CITY of BRISBANE

Open Space and Ecology Committee Meeting Agenda

- [C.](#) Review submitted OSEC Baylands DEIR comment

- [D.](#) Now collecting comments on 2025 Draft Baylands Specific Plan

FIG 6.8.32- GREEN SHARED STREET PLAN

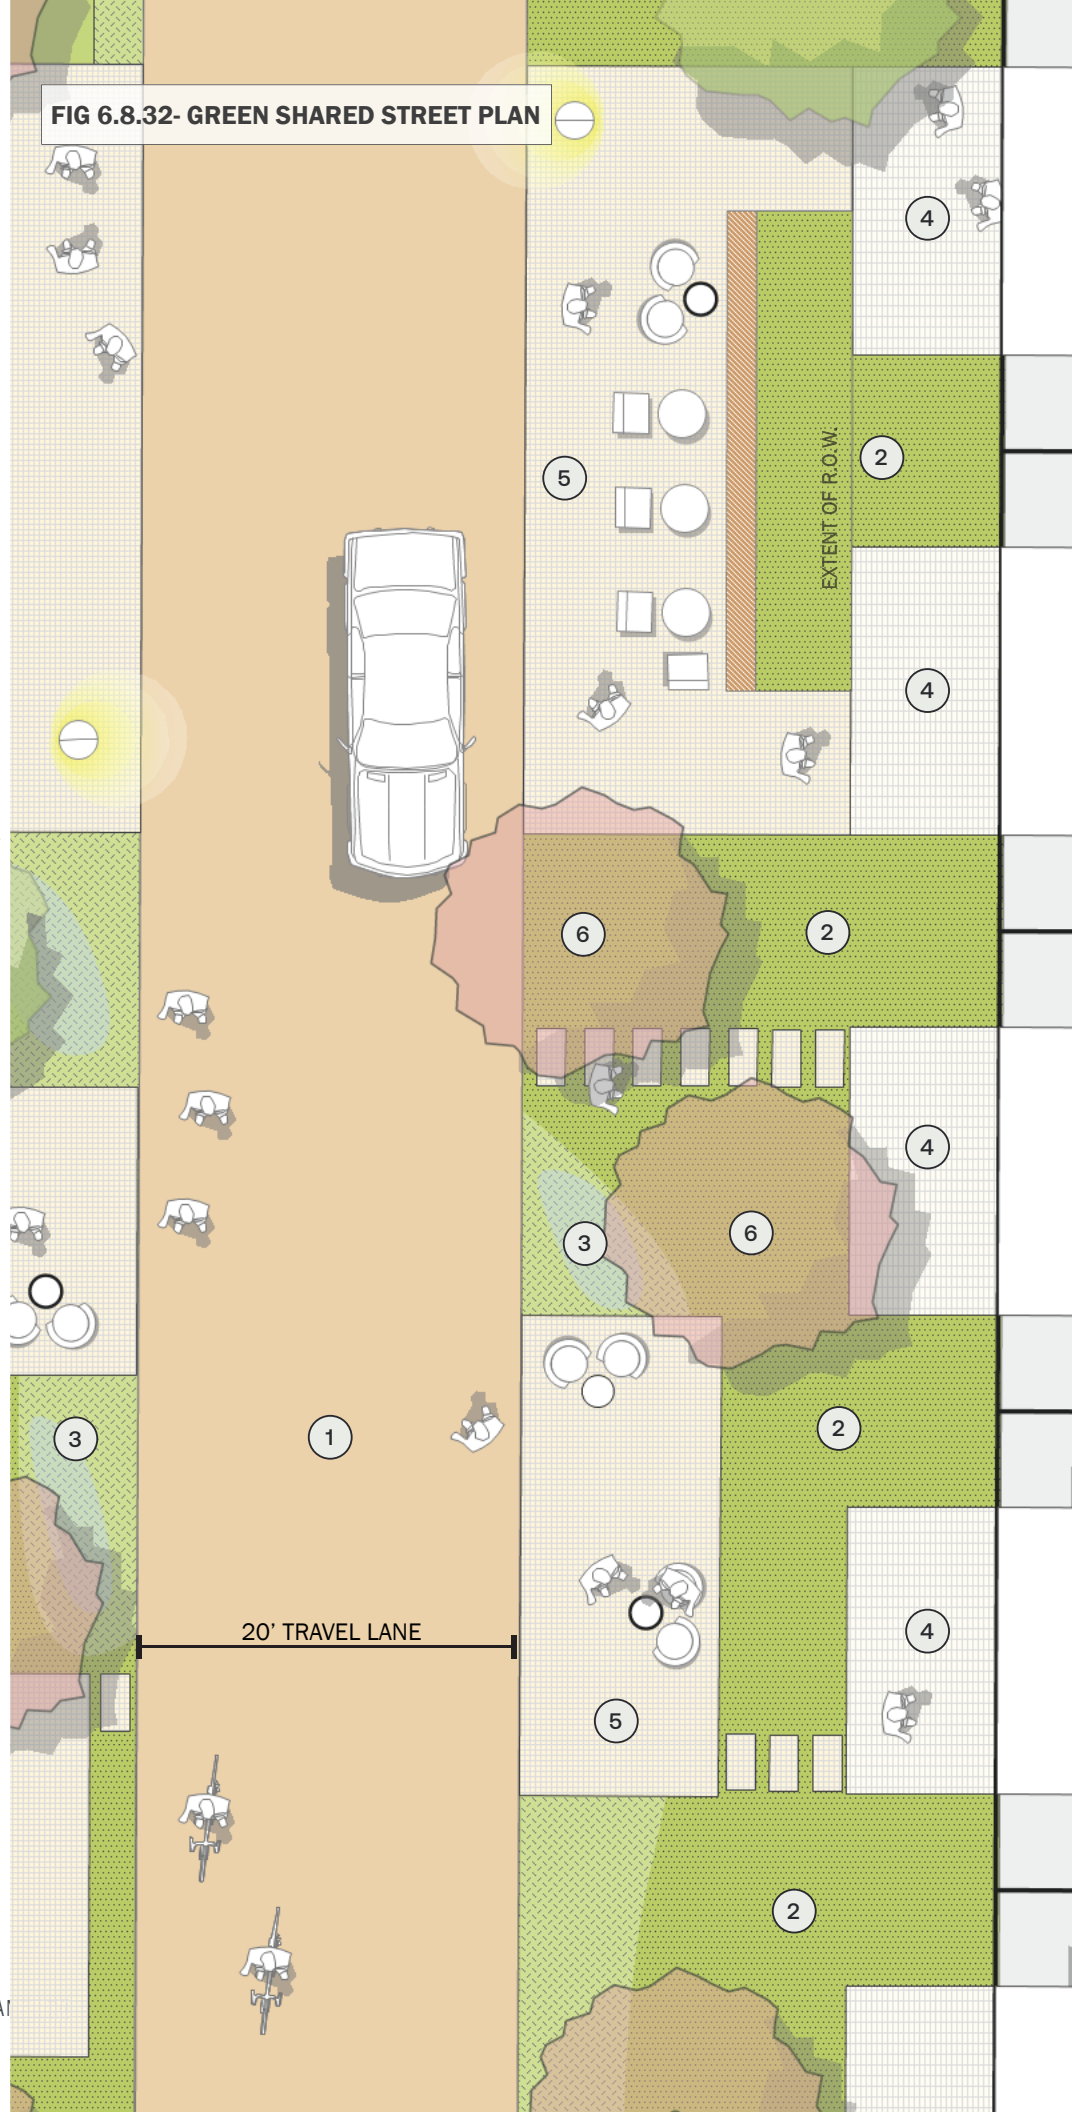
Revise to reflect the updated Specific Plan Boundary. Additionally, remove the north-south street running from Geneva Avenue to Lagoon Road.
